Calvert Cliffs Nuclear Power Plant
Unit Nos. 1 & 2; Docket Nos. 50-317 & 50-318
Facility Operating License Nos. DPR-53 and DPR-69

Subject: License Amendment Request: Adoption of Technical Specification Task Force Traveler (TSTF) – 425, Revision 3, Relocate Surveillance Frequencies to Licensee Control – RITSTF Initiative 5b

ATTACHMENT (1)

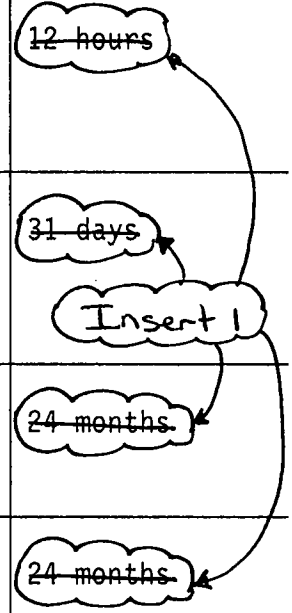
SURVEILLANCE	FREQUENCY
SR 3.4.13.1 ----- NOTES ----- 1. Not required to be performed until 12 hours after establishment of steady state operation. 2. Not applicable to primary to secondary LEAKAGE. ----- Verify RCS Operational LEAKAGE is within limits by performance of RCS water inventory balance.	Insert 1 72 hours

SURVEILLANCE	FREQUENCY
SR 3.4.13.2 -----NOTE----- Not required to be performed until 12 hours after establishment of steady state operation. ----- Verify primary to secondary LEAKAGE is ≤ 100 gallons per day through any one SG.	 Insert 1 72 hours

SURVEILLANCE	FREQUENCY
SR 3.4.16.1 Verify THERMAL POWER $\leq$ 5% RTP.	1 hour

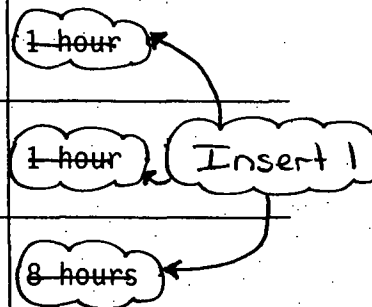
Insert 1
